Dodge Truck Adapter Harness

The Problem

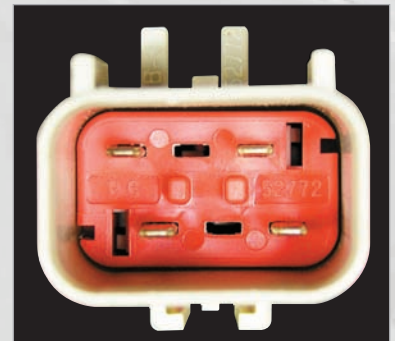
Several fuel pump assembly applications for 1996-1997 Dodge trucks contain an adapter harness to plug into the original vehicle wiring harness.

The adapter harness on the replacement fuel pump assembly has a 4-pin connector, which differs from the 6-pin connector on the original fuel pump assembly.

The original fuel pump assembly unit only uses 4 of the 6 pins in the connector. The vehicle harness, though containing 6 pins, only uses 4.

- The OE vehicle harness mates with the replacement unit adapter plug.
- Though they differ in appearance, the mating connectors are correct and perform to the OE specification.
